UNITED STATES PATENT AND TRADEMARK OFFICE

APPLICATION NO.	FILING DATE	FIRST NAMED INVENTOR	ATTORNEY DOCKET NO.	CONFIRMATION NO.
10/690,861	10/22/2003	Sean Christopher Erickson	03-1823	9543

Office Action Summary	Application No. 10/690,861	Applicant(s) ERICKSON ET AL.	
	Examiner Eric W Thomas	Art Unit 2831

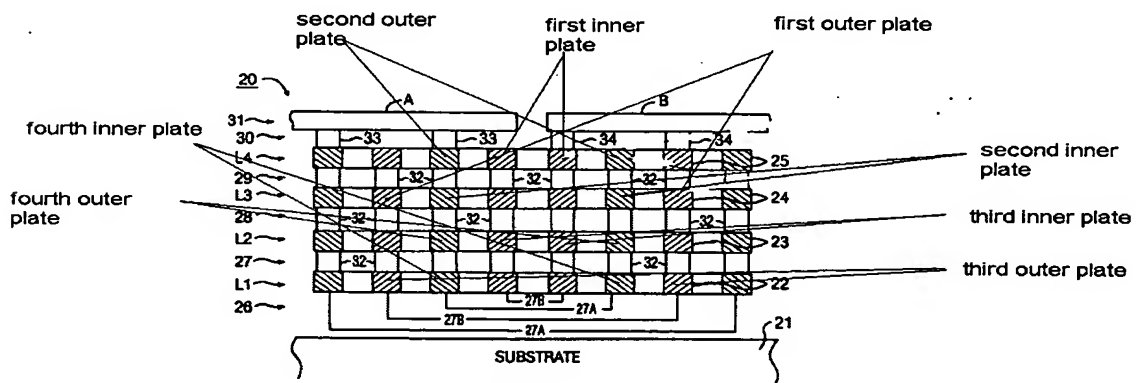
Vathulya et al. disclose in fig. 2-4, a first conductive section (see above) having a first outer plate connected to a first inner plate; and a second conductive section having a second outer plate connected to a second inner plate, wherein the second inner plate is located within a first hole in the first outer plate and the first inner plate is located within a second hole in the second outer plate such that a first distance is present between the second inner plate and the first outer plate and a second distance is present between the first inner plate and the second outer plate.

Regarding claim 3, Vathulya et al. illustrate in fig. 2, the first outer plate and the second outer plate have a rectangular shape.

Regarding claim 4, Vathulya et al. disclose the first distance is equal to the second distance (as illustrate in fig. 4).

Regarding claim 7, Vathulya et al. disclose a third conductive section (below first and second section – see the above fig) having an third outer plate connected to a third inner plate; and a fourth conductive section having a fourth outer plate connected to a fourth inner plate, wherein the fourth inner plate is located within a third hole in the third outer plate and the third inner plate is located within a fourth hole in the fourth outer plate such that a third distance is present between the fourth inner plate and the third outer plate and a fourth distance is present between the third inner plate and the fourth

Regarding claim 8, Vathulya et al. disclose the third outer plate is located below the first outer plate, fourth outer plate is located below the second outer plate, the third inner plate is located below the first inner plate, and the fourth inner plate is located below the second inner plate.

Regarding claim 9, Vathulya et al. disclose the first conductive section is connected to a third conductive section by a first set of via connections (32) and wherein the second conductive section is connected to the fourth conductive section by a second set of via connections (32).

Regarding claim 12, Vathulya et al. disclose the first outer plate is connected to the first inner plate by a first metal line (B) and wherein the second outer plate is connected to the second inner plate by a second metal line (A).
